SUBDIVISION REPORT - CONCEPT/DEVELOPMENT PLAN

▶ **FILE #:**	**8-SB-26-C**	**AGENDA ITEM #:**	**15**
	8-B-26-DP	**AGENDA DATE:**	**10/1/2026**
POSTPONEMENT(S):	8/13/26, 9/10/2026		
▶ **SUBDIVISION:**	**CARTER VALLEY (FORMERLY CARTER MILL, PHASE 9)**		
▶ **APPLICANT/DEVELOPER:**	**SKYCREST ENGINEERING SERVICES LLC**		
OWNER(S):	Winston D Cox Carter Mill LLC

CONCEPT PLAN / DEVELOPMENT PLAN **8-SB-26-C / 8-B-26-DP**

CONCEPTUAL PLAN
CARTER VALLEY

SHEET TITLE:
PROFILES

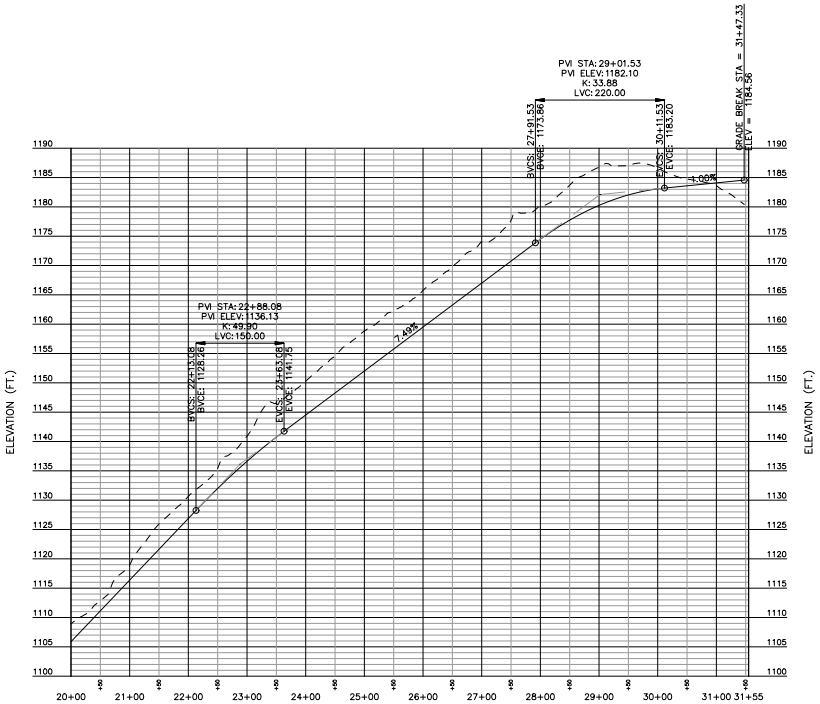
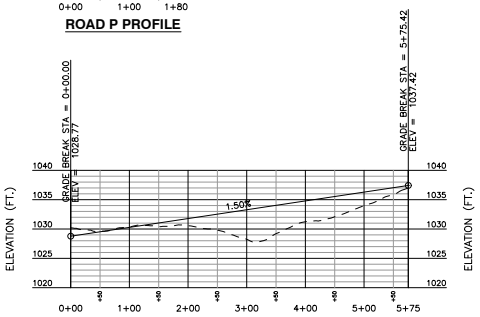
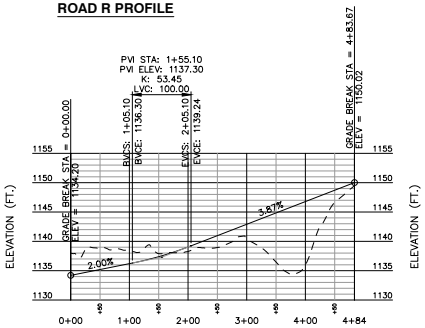
1) Increase the maximum intersection grade of Road 'N' from 1 percent to 2 percent at Carter Mill Road.
2) Increase the maximum intersection grade of Road 'O', Road 'P', Road 'Q', and Road 'R' from 1 percent to 2 percent at Road 'N'.

Increase the minimum intersections grade from 1% to 2% at the intersections of Road P at Road N, Road Q at Road N, Road O at Road N, and Road N at Carter Mill Drive.

APPROVED
By Steve Elliott at 1:11 pm, Aug 06, 2026

Internal Traffic Sign Locations

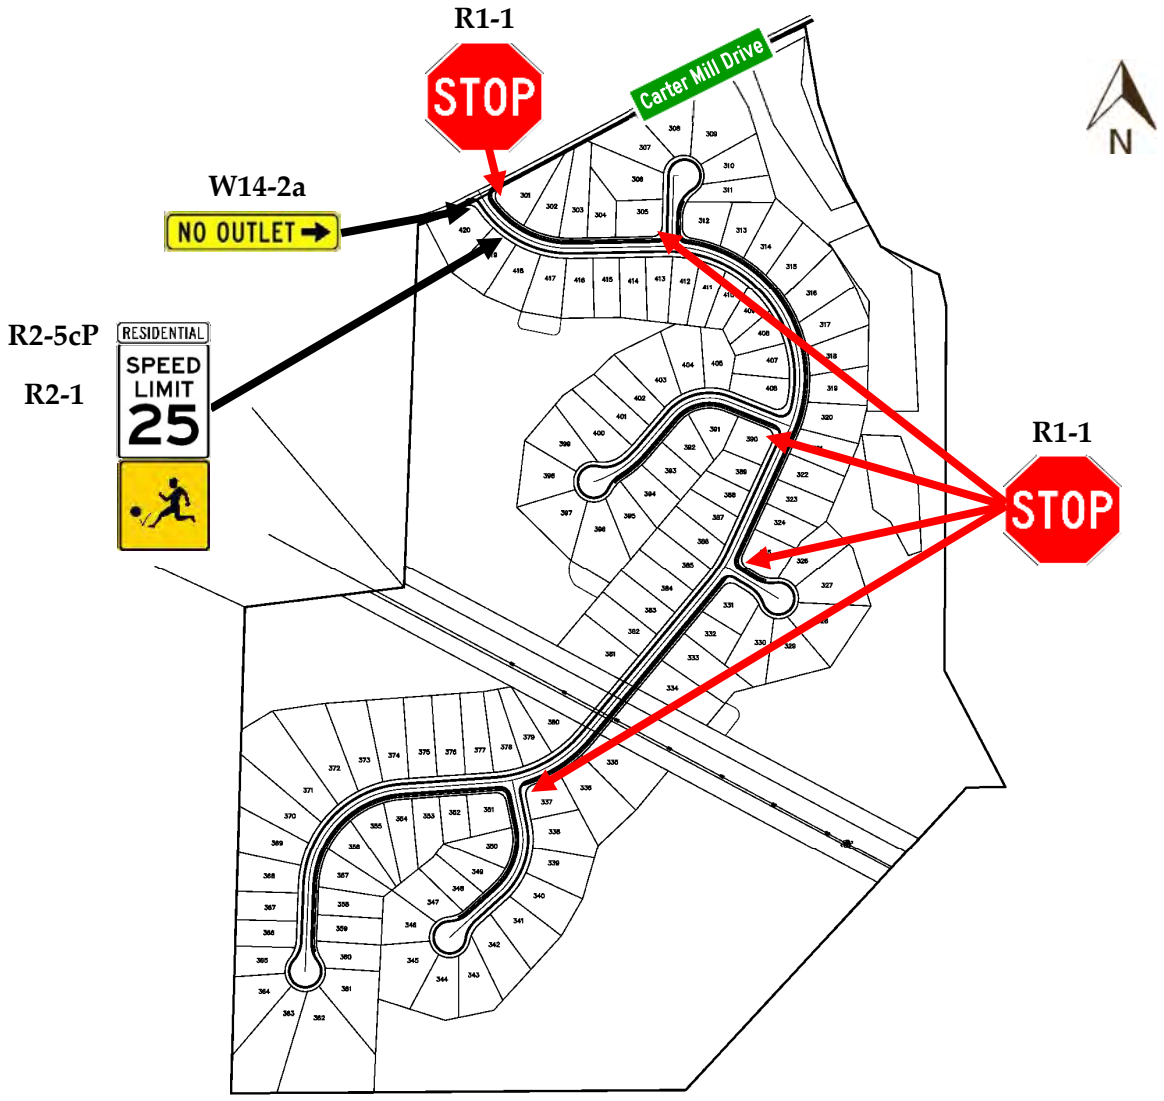
2b) Stop Signs (R1-1) are recommended to be installed on the minor approaches at the internal roadway T-intersections, as shown in the image below with other recommended signage.

2c) Sight distances at the new internal intersections must not be impacted by new signage, parked cars, or future landscaping. The civil site designer should ensure that appropriate internal sight distances will be met.

Knox County Engineering and Public Works Minimum Standard Line – ADT vs. Road Width

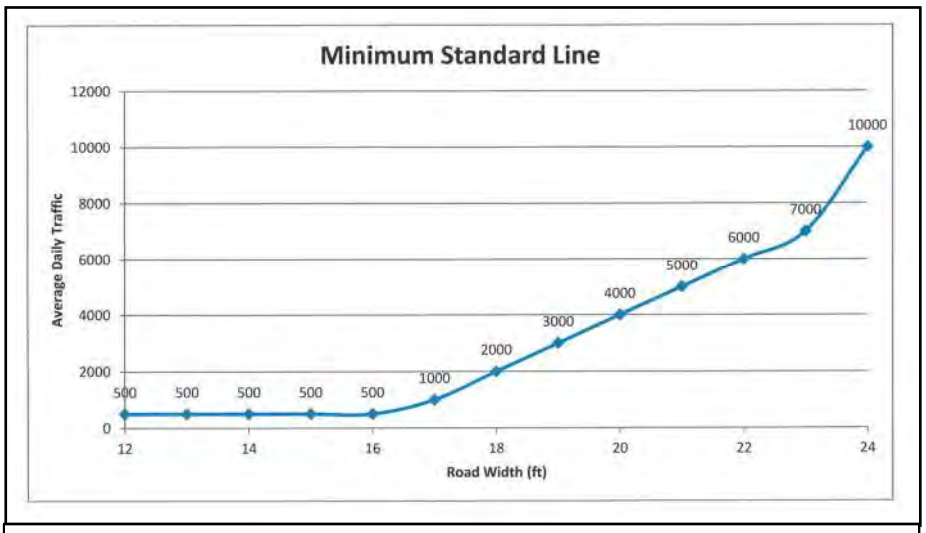
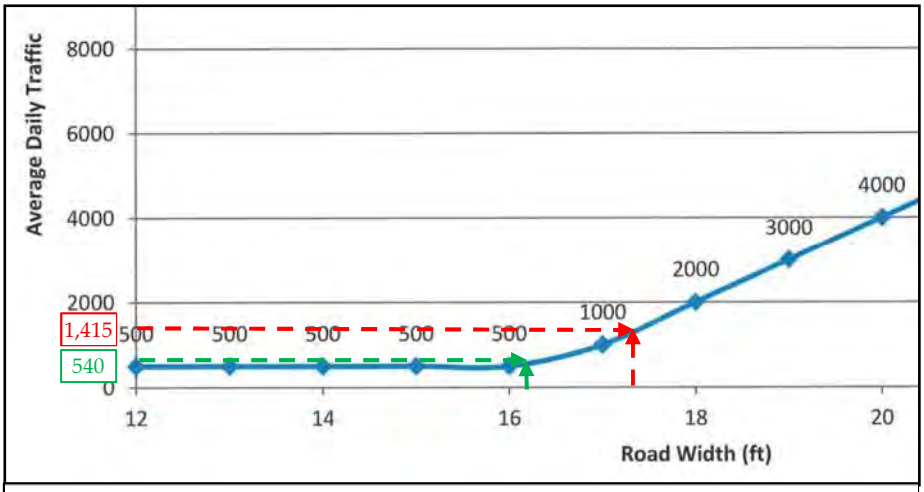
According to the Knox County chart, the current estimated daily traffic on the western section of Carter Mill Drive would indicate a desired road width just over 16 feet. Carter Mill Drive, on its western section, had road width measurements between Station 12+50 and 42+50 that ranged from 13.6 feet to 17.6 feet, with most measurements being in the 14 – 16-foot range, less than desired, as demonstrated in the graph.

A road width of 18 feet would be appropriate for up to approximately 2,000 vehicles per day based on Knox County's ADT/road width minimum standard. The projected 2029 daily traffic volume on the western section of Carter Mill Drive, including traffic from Phases VI–IX, is estimated at approximately 1,415 vehicles per day — well below this threshold.

Therefore, widening the western section of Carter Mill Drive to a target width of 18 feet is recommended as the ultimate goal by the time all phases of the Carter Ridge Subdivision are completed and occupied in 2029. This width will provide adequate capacity and improved safety for projected traffic volumes. Widening this section beyond 18 feet to a full 20 feet to match the eastern portion of Carter Mill Drive could be considered impractical in many locations due to the more aggressive terrain, winding horizontal alignments, and right-of-way constraints present on the western end. Widening beyond 18 feet could also encourage higher vehicle speeds, which would be incompatible with the existing geometry, steep grades, and roadside hazards.

5. Widening Carter Mill Road to 20 ft along the full length of the property's frontage, and to 18 ft from the western edge of the property to the McCubbins Road intersection to ensure safe roadway conditions after the construction of this subdivision. The AASHTO publication "Guidelines for Geometric Design of Low - Volumes Roads 2019" identifies roadways like Carter Mill Road as a Minor Access Road and for traffic volumes between 400-2000 ADT the minimum width recommended is 18 feet.
